CITY OF RIVERSIDE, CALIFORNIA
DEPARTMENT OF PUBLIC WORKS

STREET PLAN & PROFILE
PALMYRITA AVENUE
BETWEEN A.T. & S.F. R.R. and CALIFORNIA AVENUE

APPROVED BY J. F. Davidson
Director of Public Works
NO. R 693
DATE Aug 9, 1963
SHEET 1 OF 1

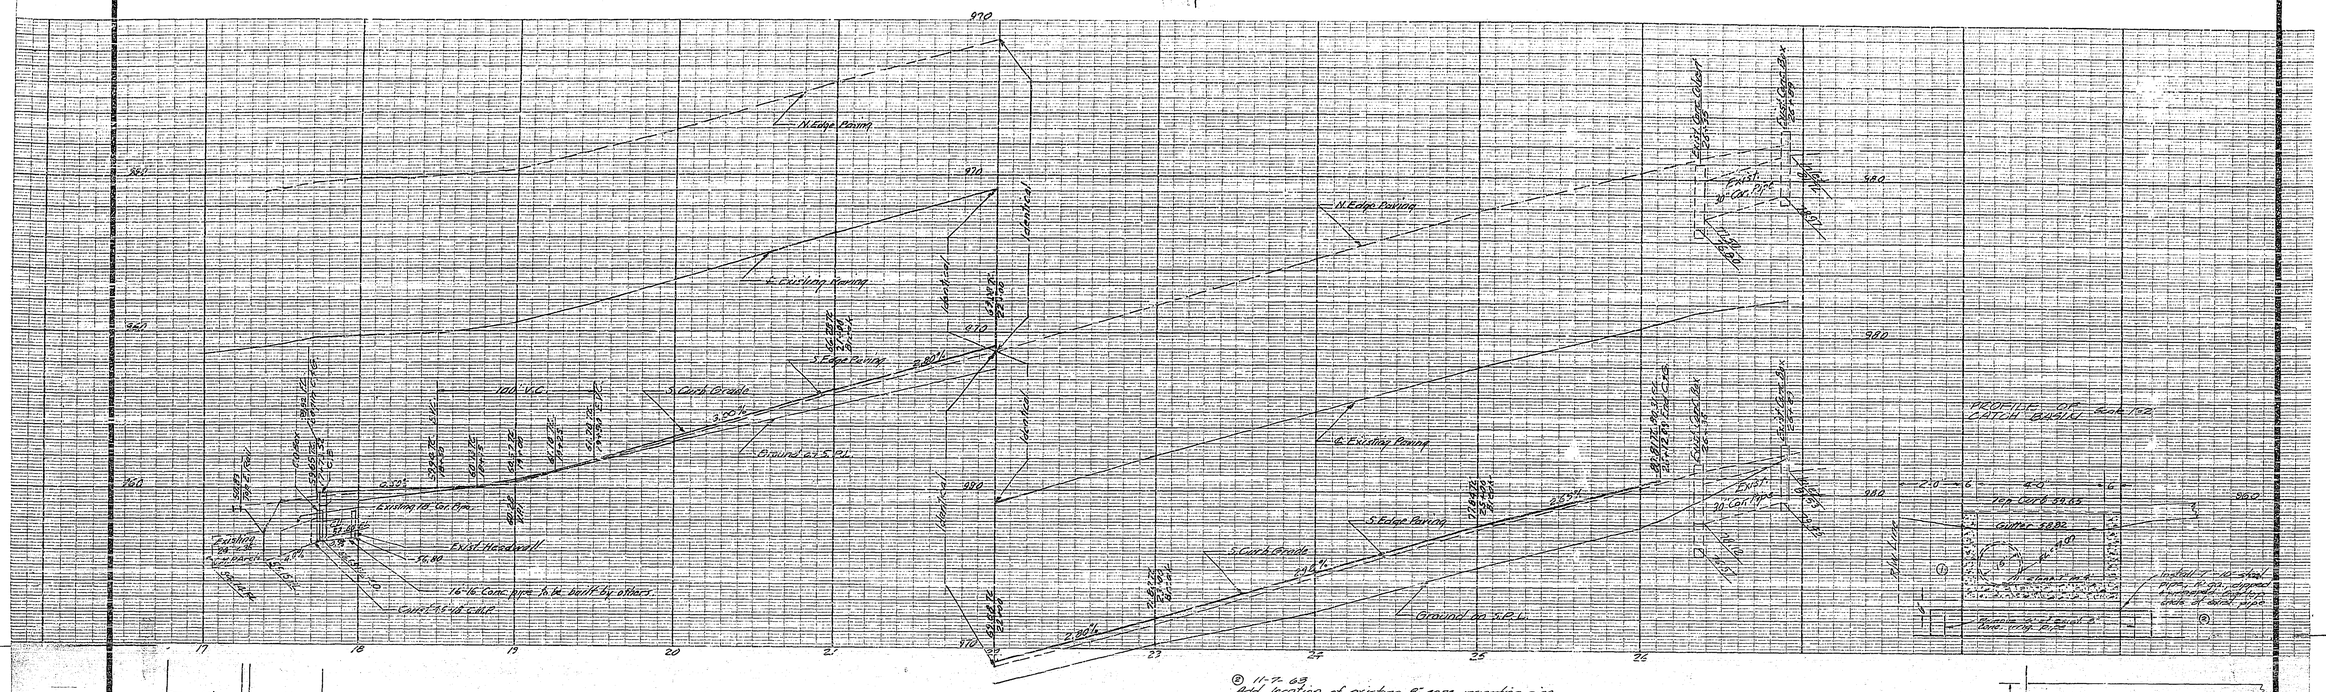
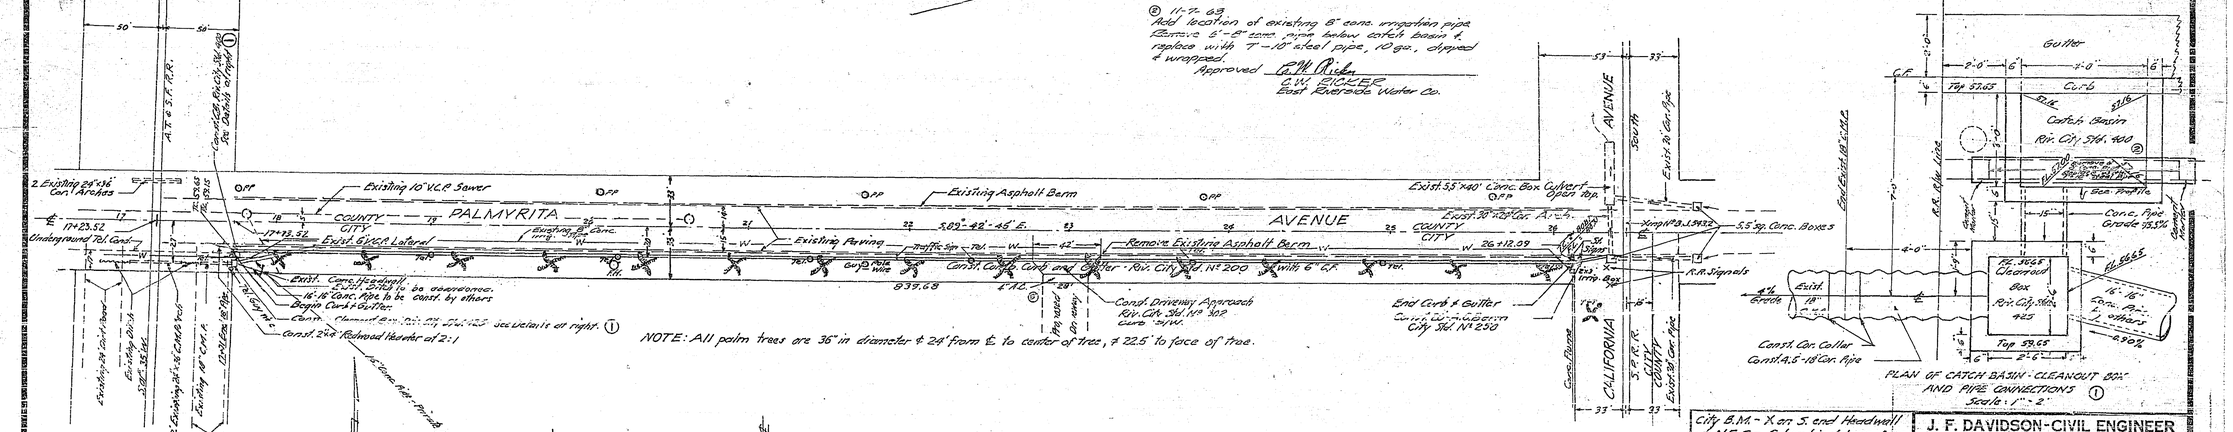
⑧ 11-7-63
Add location of existing 8" conc. irrigation pipe. Remove 6'-8" conc. pipe below catch basin & replace with 7'-10" steel pipe, 10 ga., dipped & wrapped.
Approved R.M. Ricks
R.M. RICKS
East Riverside Water Co.

① 10/11/63 Relocate C.B. & Co. Assembly
C.J. Davidson

⑦ 11-7-63 Add location of 8" conc. pipe & installation of 10" steel pipe
J.D. Fain

⑧ 11-7-63 Add location of existing irrigation pipe
Approved R.M. Ricks
ADD 1 to 8
